*Decay Heat Removal Problem Associated With
Recovery From a Very Small Break LOCA
for CE System 80 PWR*

Nuclear Systems Analysis Section

May, 1977

FIGURE 1

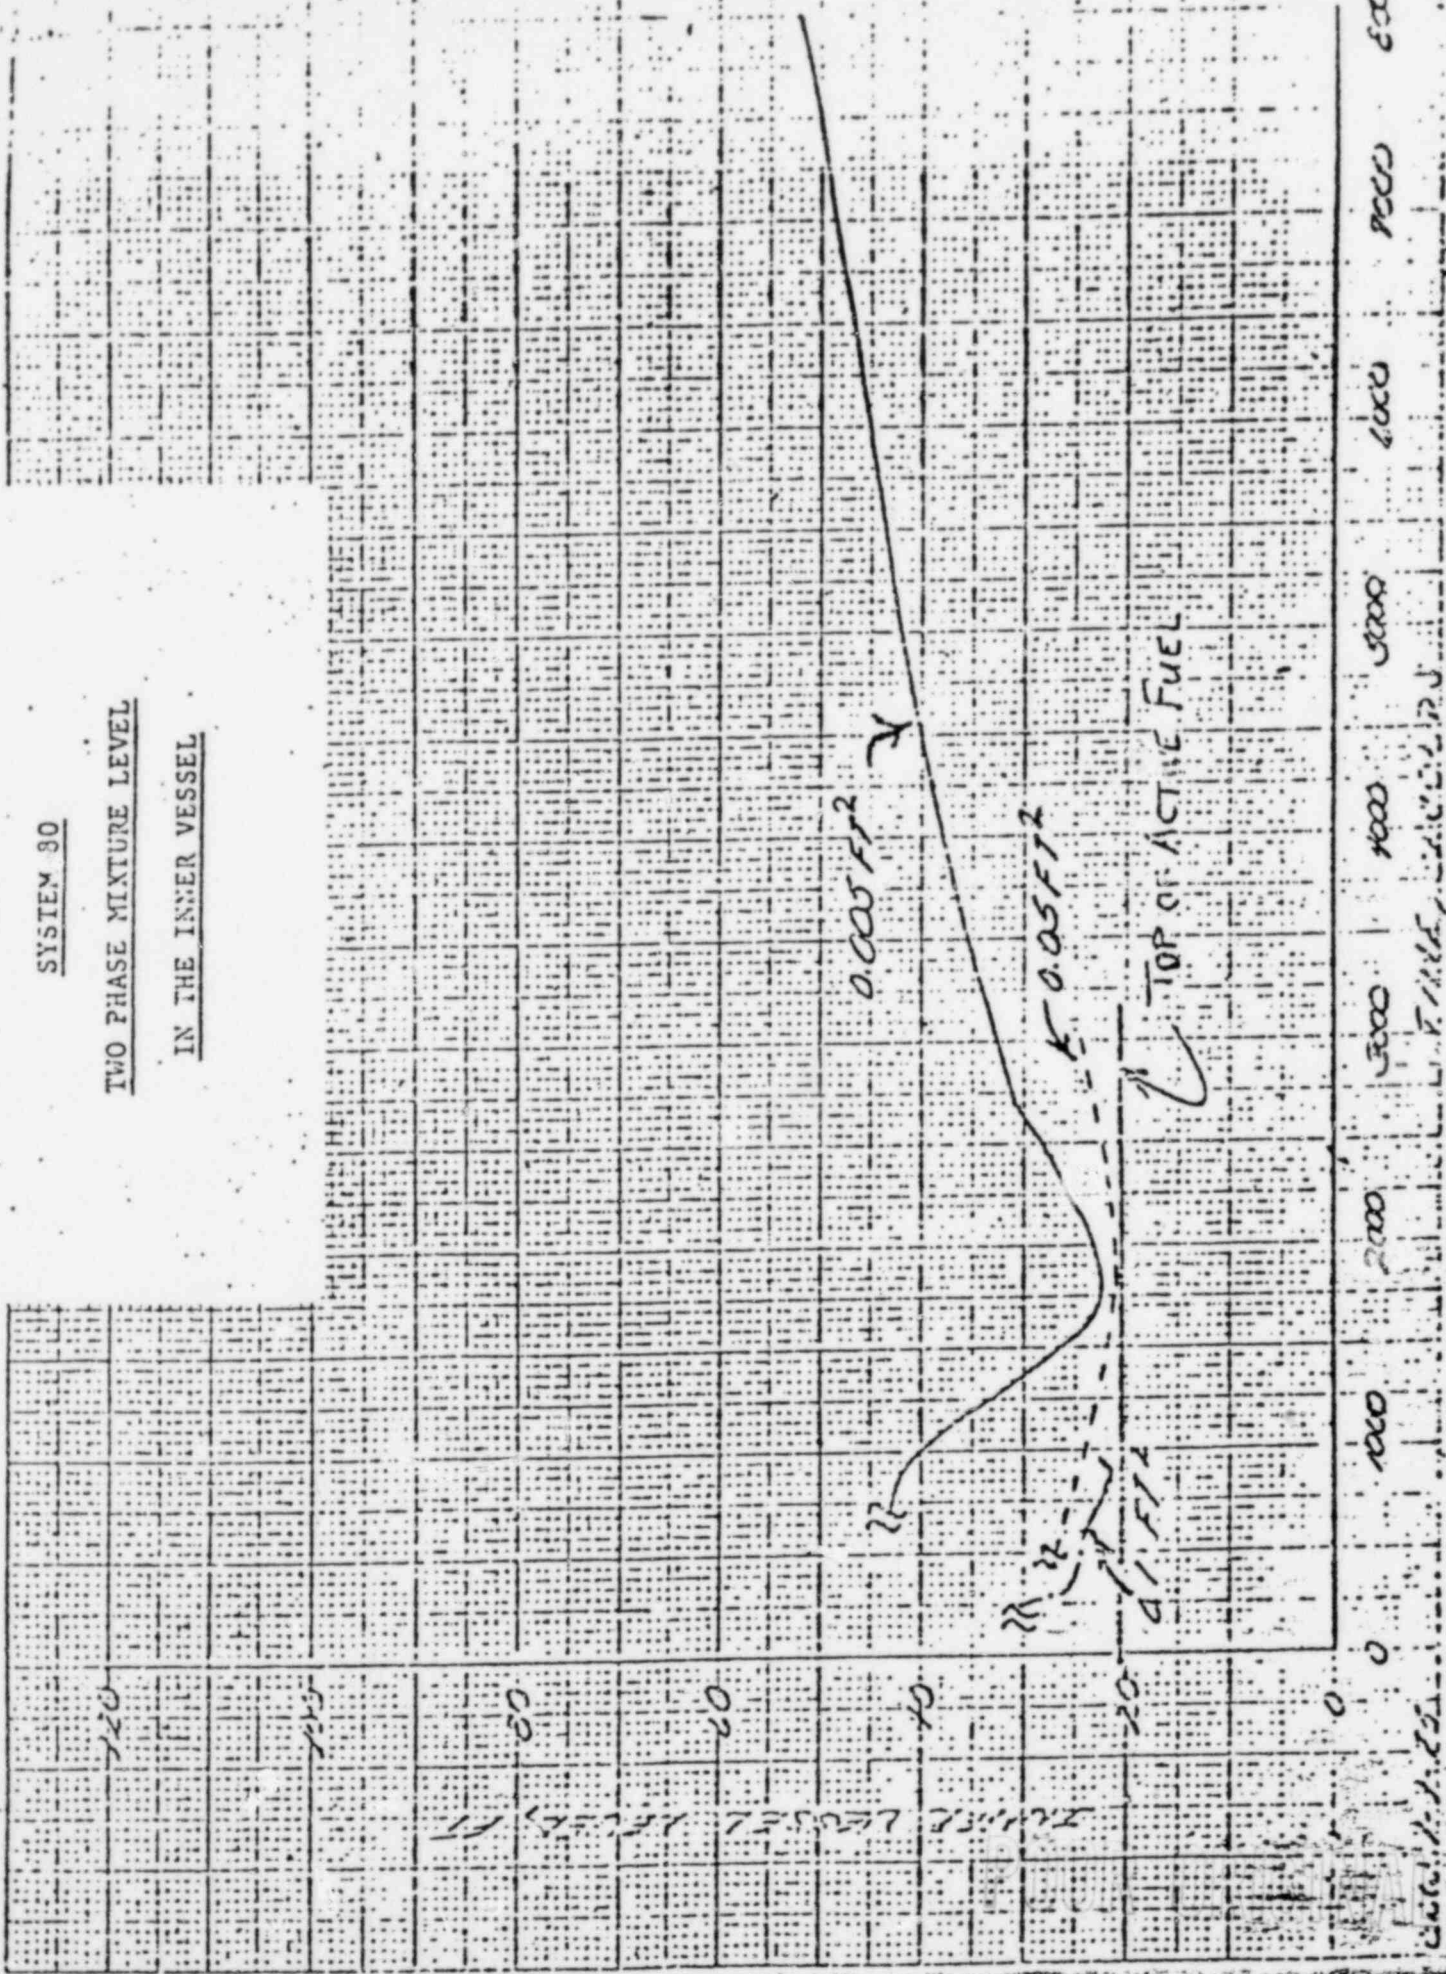
The results shown in Figure 1 of Appendix B indicate that the reactor vessel level will drop into the hot leg piping for each assumed break size within 15 to 30 minutes following the break, thus leading to the predicted occurrence of the first six modes of operation outlined in Appendix A. The results show that the core will remain covered at all times including Mode 4 operation.

(Notice margin to uncover for

very small (ca. thus being likely Small break

General

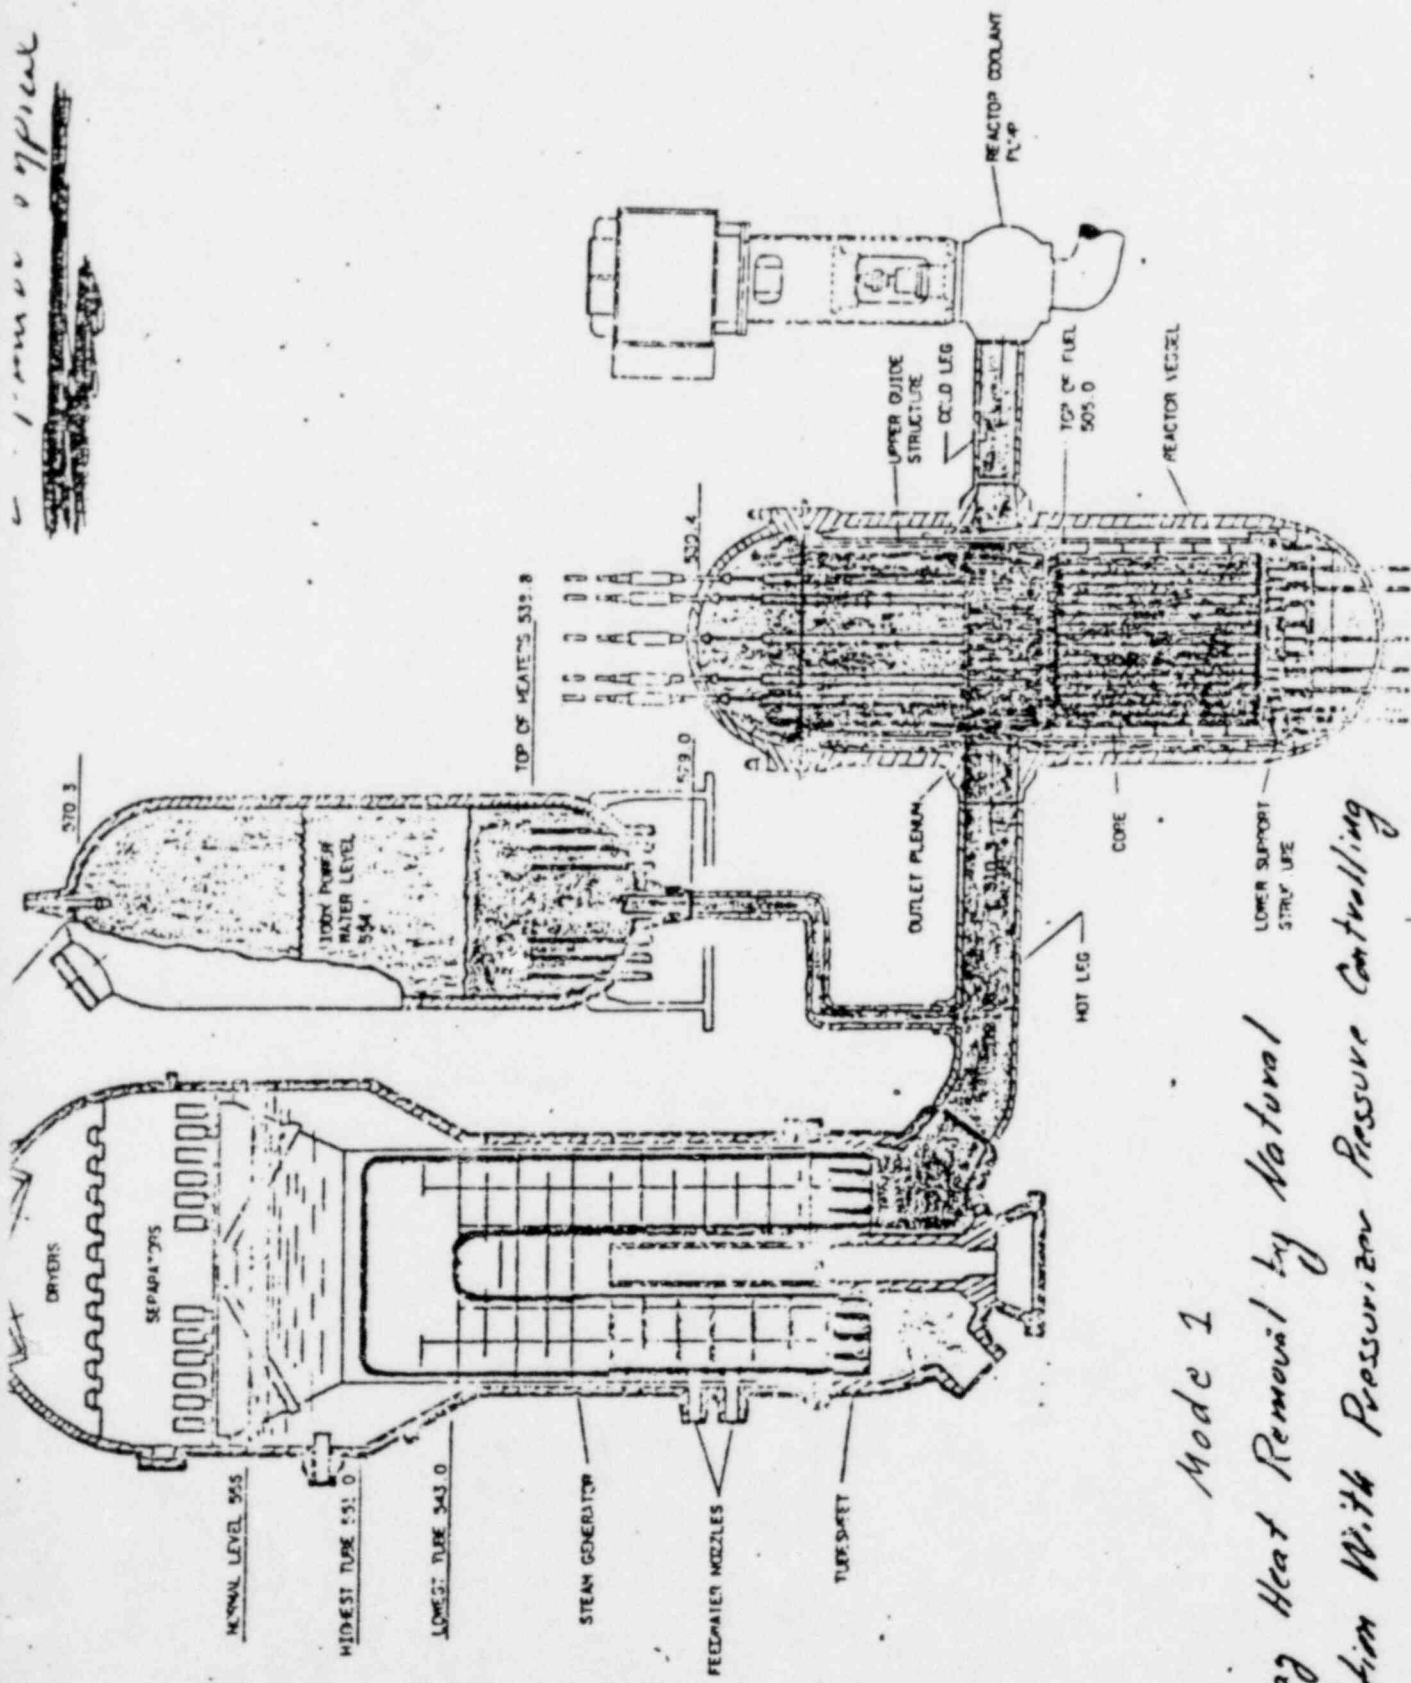
It appears it might be argued that as long as fuel is used (and fuel would not have been initially damaged by small break efforts)

Damage to S/G tubes might not be of much significance unless a large amount of water superheated above the 1100 ps. sat. temp of the secondary side had somehow accumulated in the primary loops because of inadequate "natural circulation" cooling. If this condition could exist - potential for overpressurization of the secondary system would exist.

In any case calculations should predict the course of water level including the transition to refill.

It is worth noting that immediately after startup after a long shutdown (or preferably with a new core) tests could be run with very little risk since ² at low fissile point strains would immediately terminate the test generation problem.
